Proposed Plan Change 60 to the
Wairau/Awatere Resource
Management Plan

SECTION 42A REPORT

Proposed Plan Change 60

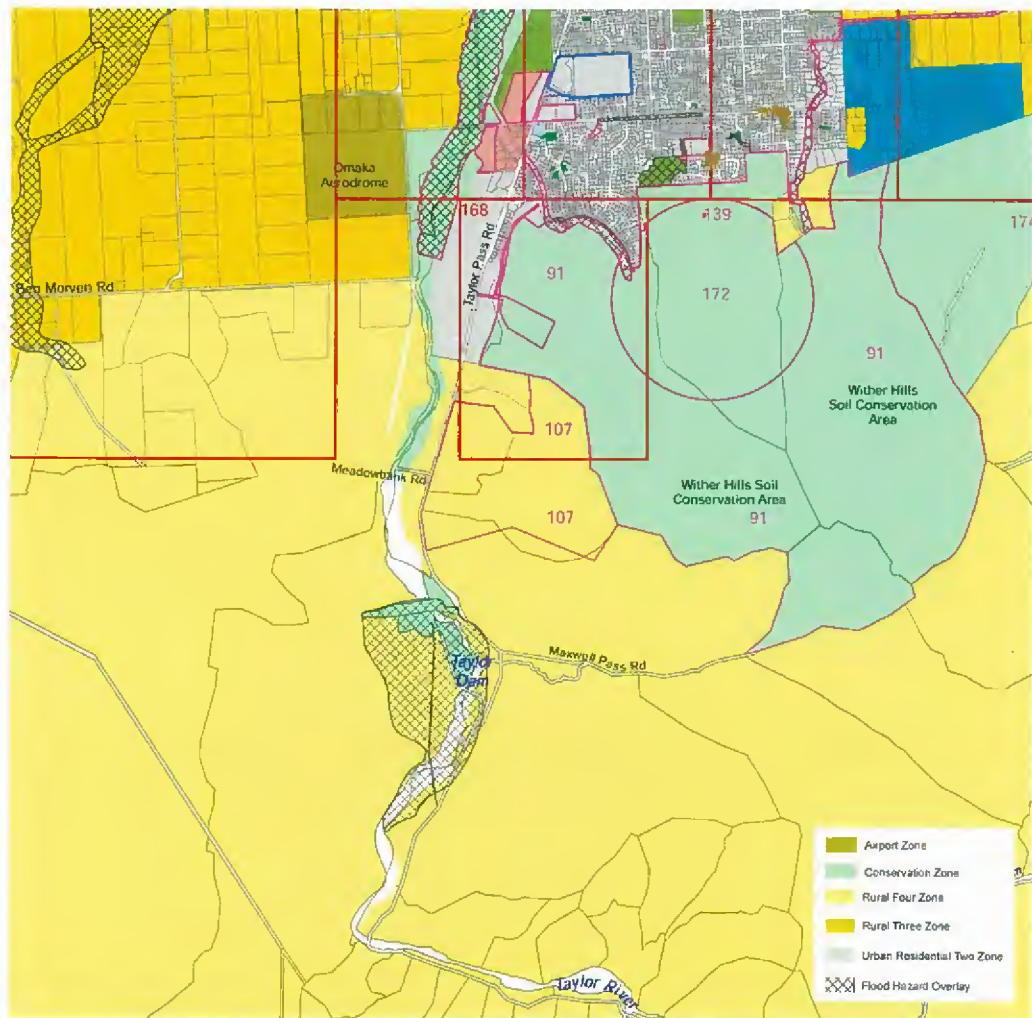
It is acknowledged that the Plan Change Site does not form part of an outstanding natural landscape or feature, however it is noted that the Site as existing does hold rural amenity values that contribute to the local rural landscape character. Within Chapter 5, the Site would fall into the Dry Hills (The passes) landscape area within the table on pages 5-2 and 5-3, where the landscape sensitivity is medium. Although not completely relevant to all of Objective 1 (i.e. the Site is not outstanding and not of the highest sensitivity), the remainder of the objective concerns the visual qualities of the area, where Policy 1.9 targets specifically sprawling or sporadic subdivisions outside areas already occupied by residential settlement.

The Taylor Valley landscape contains some form of residential development, although not in the numbers, scale or density proposed by the Plan Change. The landscape currently holds overwhelmingly rural values, where rural based activities, such as residential properties, paddocks, vineyards and forestry are small scale and suited to the more intimate valley catchment. The large scale change proposed by the plan change will be incongruous to those rural values and introduce a scale and density of development unseen in this valley landscape.

Based on the above it is concluded that the proposed plan change does not better achieve Objective 1, particularly Policy 1.9.

Site Photograph 1: Photograph taken at the Taylor Dam, approximately 658m to the north of the Plan Change site looking southwards.

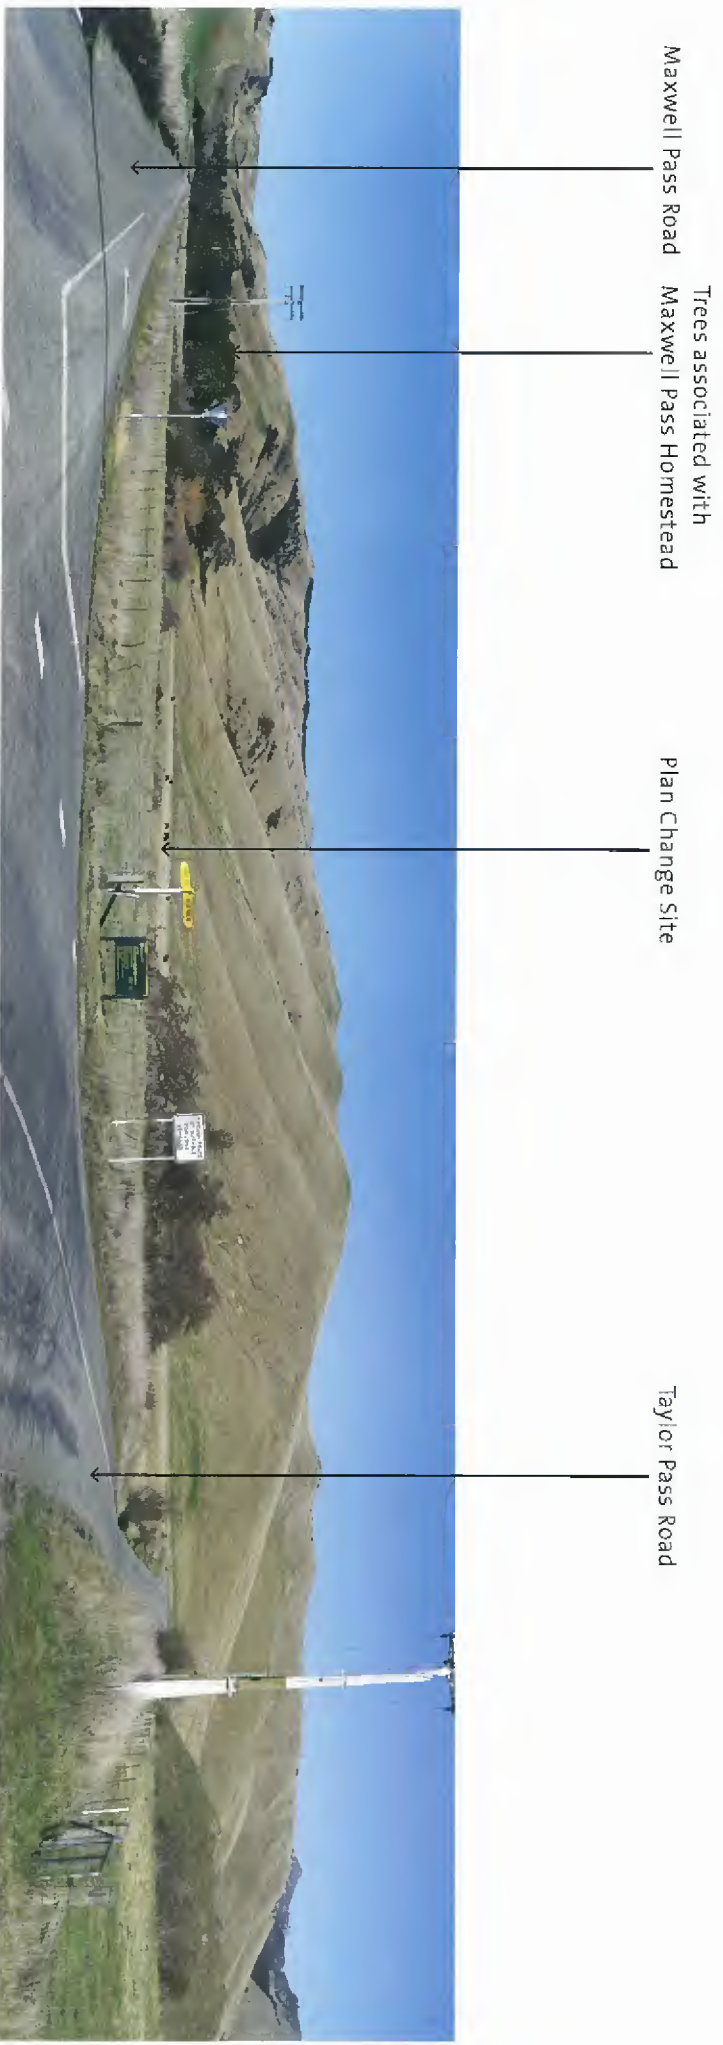
Viewpoint 1 is located at the Taylor Dam, approximately 658m to the north of the Plan Change Site looking southwards. From this viewpoint and beyond the lake, the landform of the valley is visually discernible; the flat open paddocks of the valley floor afford views of the willow lined Taylor River corridor. South of the Taylor River corridor the dry, undulating hills of the valley are unbroken by vegetation or dwellings on the skyline. The hill of Sugarloaf (288masl) forms the visual backdrop.

There are sections adjacent to the dam where views towards the Site are more or less screened by trees. A photograph illustrating this is used within the Landscape Assessment's graphic attachment as Site Panorama 8.3. Figure 7.1 (visibility plan) does not accurately portray the visibility from the Taylor Dam.
